2500360.00  
ADDENDUM NO. 1

DATE: July 2, 2026

FROM: Baxter & Woodman, Inc., Consulting Engineers

VILLAGE OF HOFFMAN ESTATES, ILLINOIS  
SHOE FACTORY ROAD WATER MAIN REHABILITATION

**UTILITY ROAD STA. 15+00 TO STA 20+00 PLAN AND PROFILE**

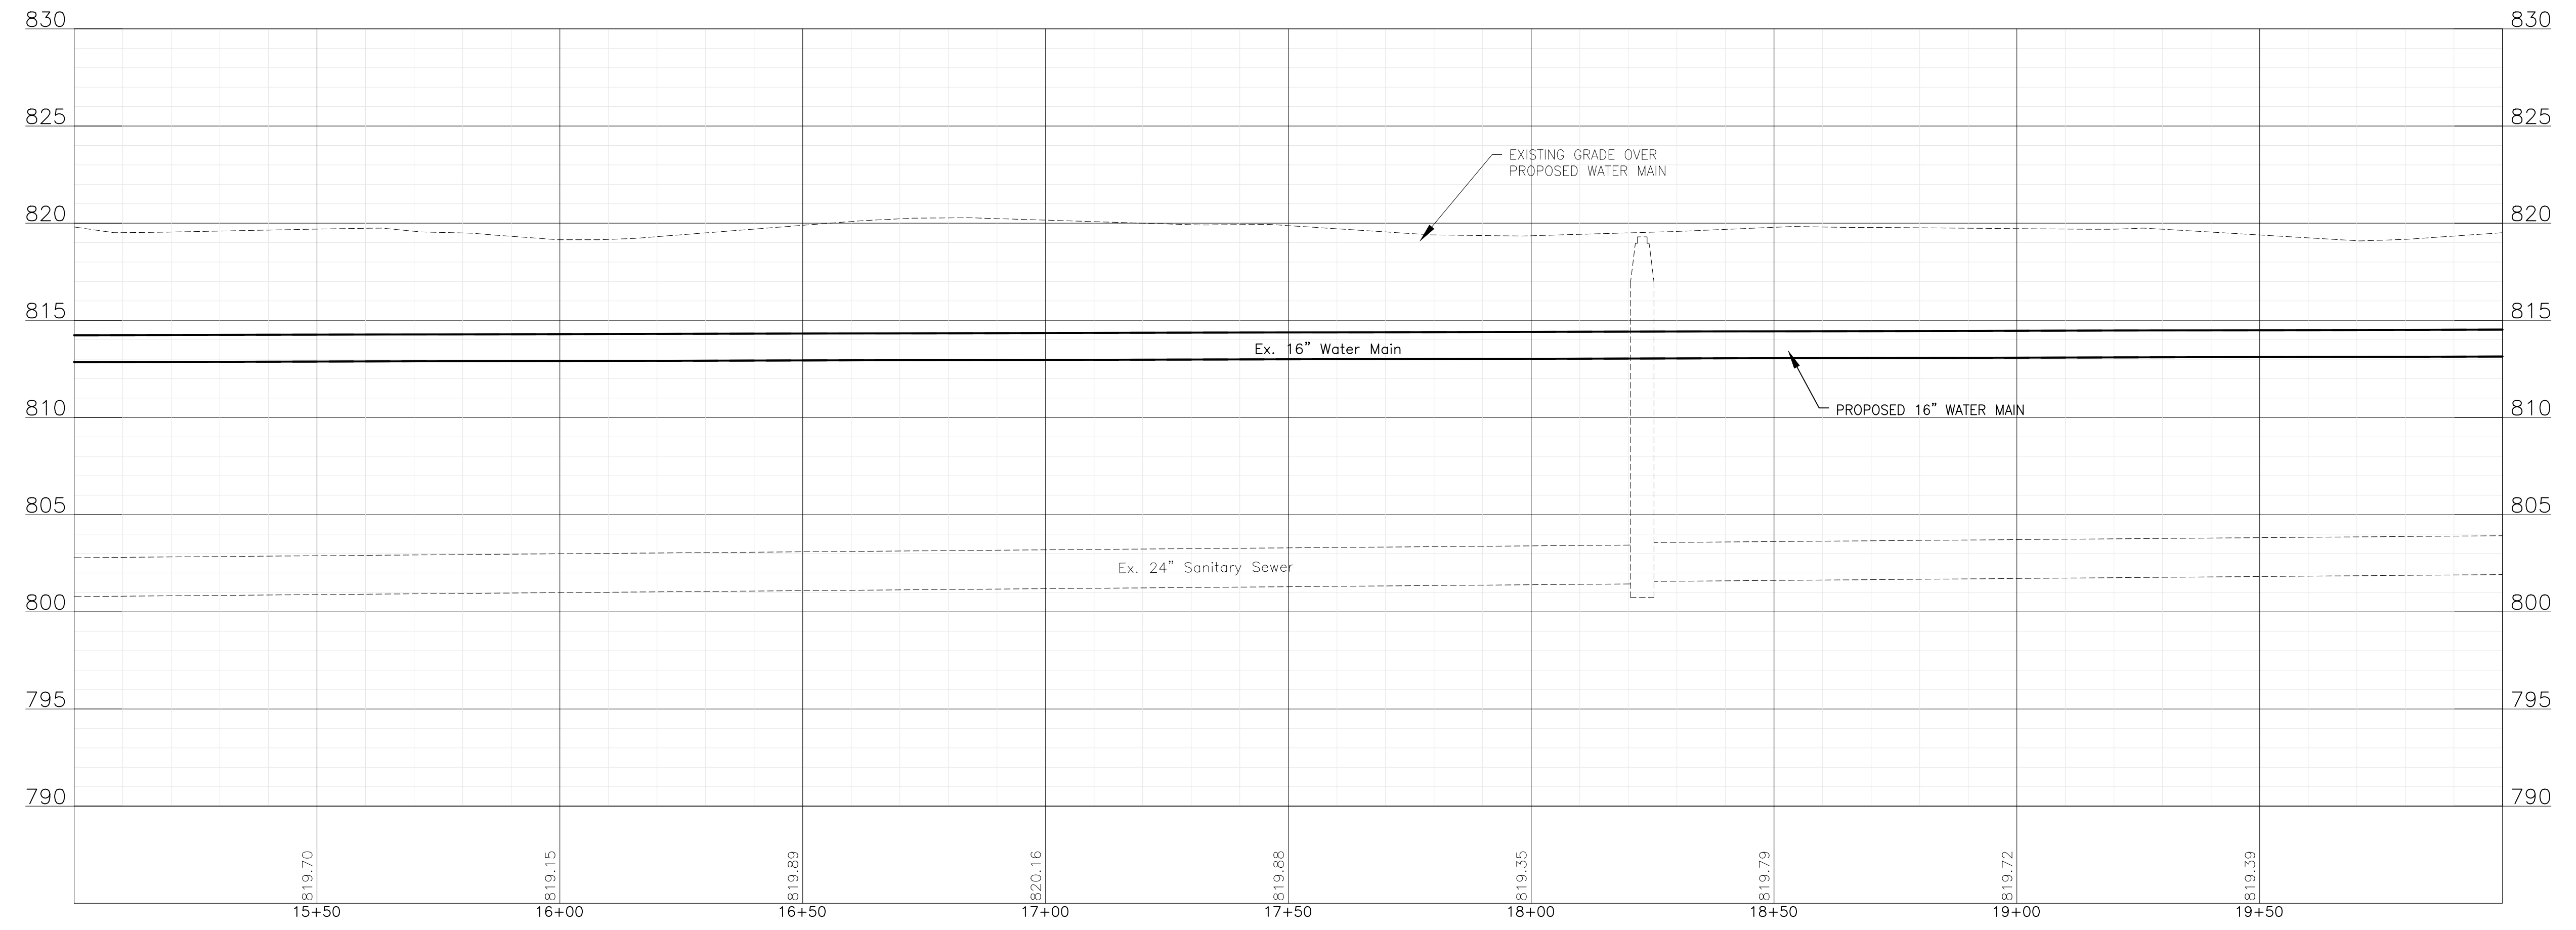
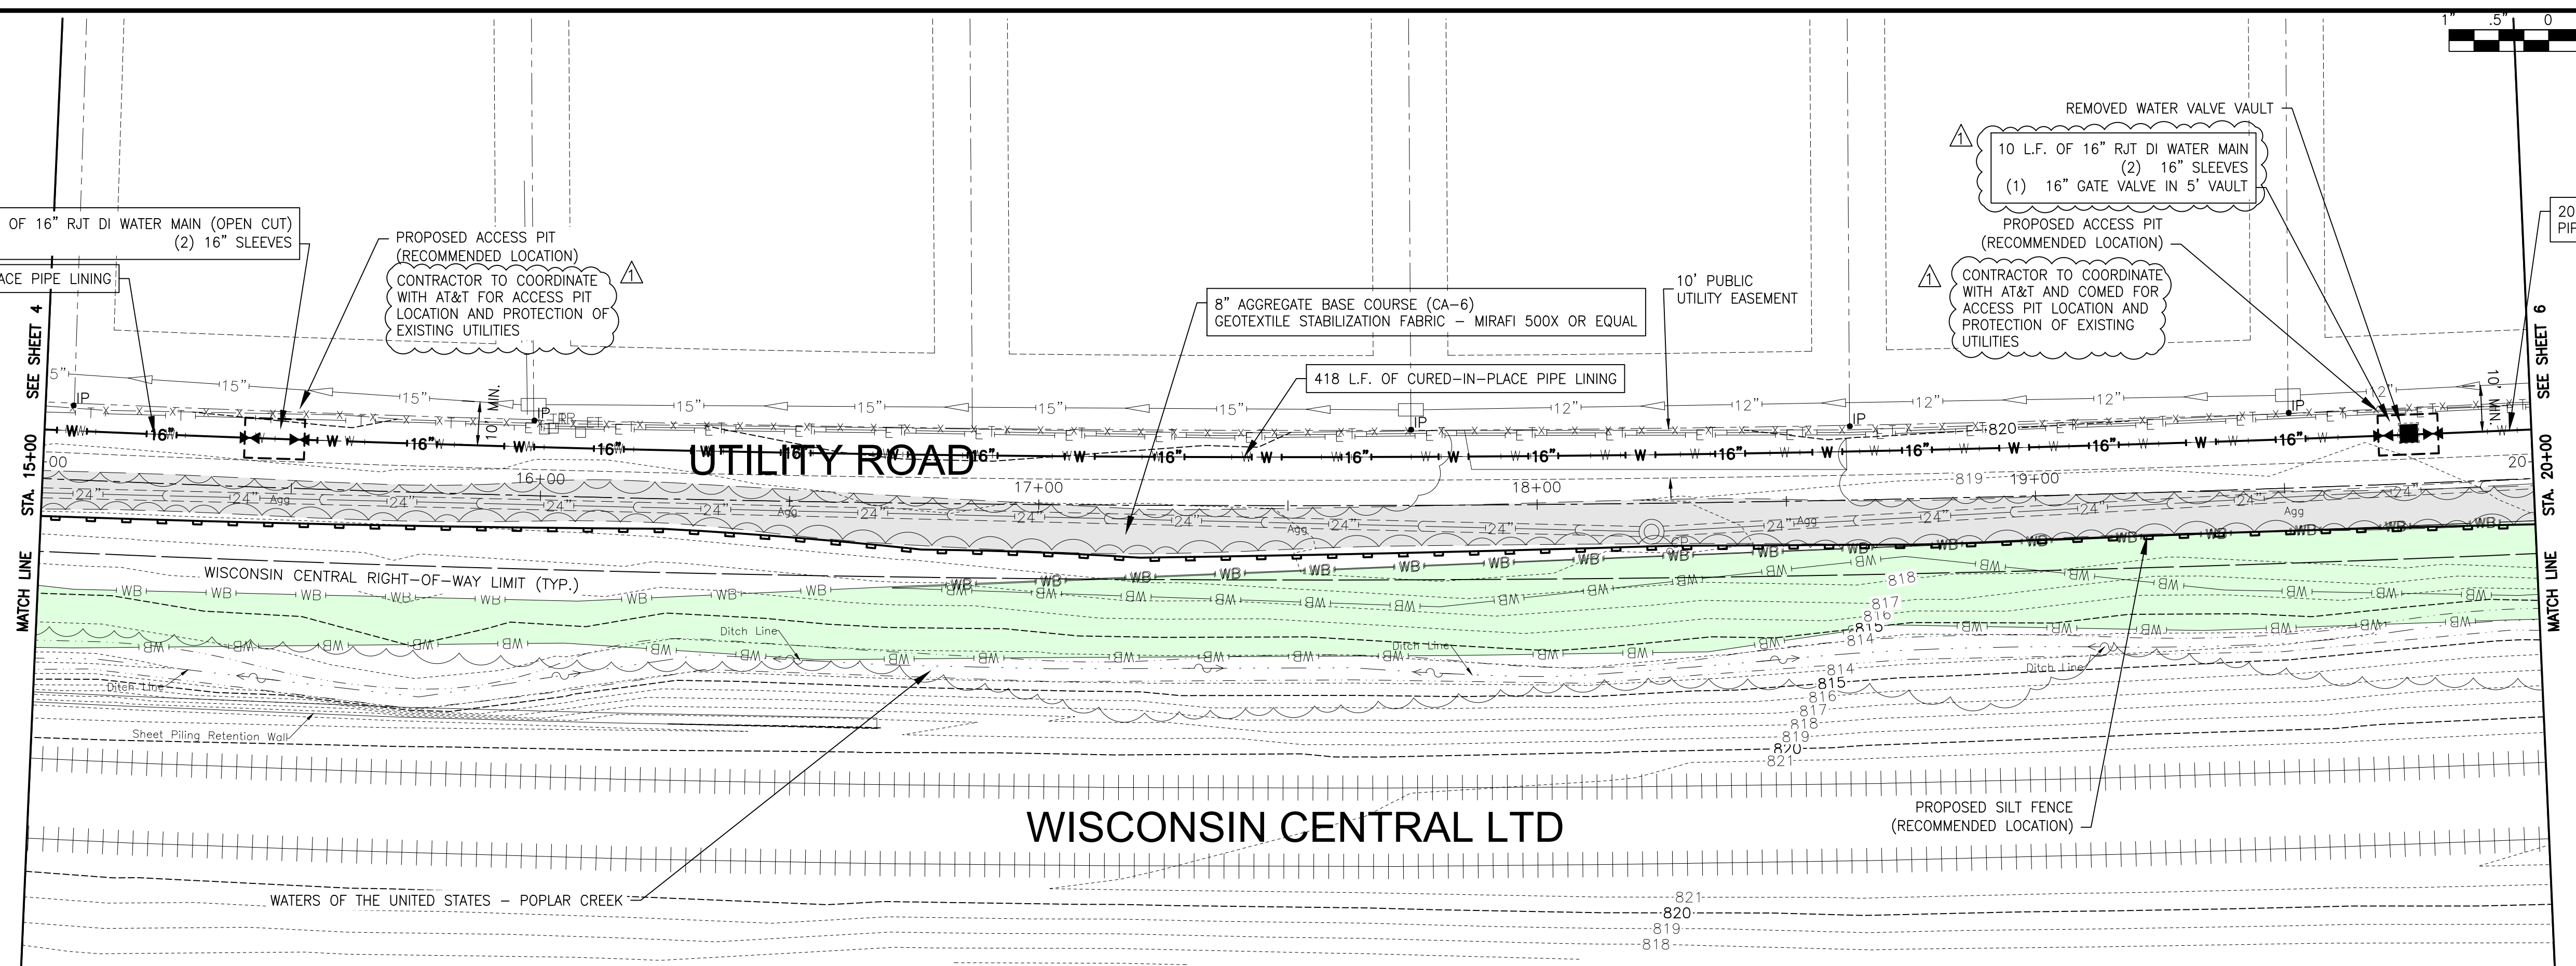
- A. Delete SHEET NO. 5 in its entirety, and insert SHEET NO. 5, revision dated July 2, 2026, in lieu thereof.
- B. Delete SHEET NO. 6 in its entirety, and insert SHEET NO. 6, revision dated July 2, 2026, in lieu thereof.
- C. Delete SHEET NO. 7 in its entirety, and insert SHEET NO. 7, revision dated July 2, 2026, in lieu thereof.

10 L.F. OF 16" RJT DI WATER MAIN (OPEN CUT)  
(2) 16" SLEEVES

41 L.F. OF CURED-IN-PLACE PIPE LINING

PROPOSED ACCESS PIT  
(RECOMMENDED LOCATION)  
CONTRACTOR TO COORDINATE  
WITH AT&T FOR ACCESS PIT  
LOCATION AND PROTECTION OF  
EXISTING UTILITIES

CONSULTANTS	REVISED - $\Delta$ ADDENDUM #1 7/2/26
	REVISED -
	REVISED -
	REVISED -
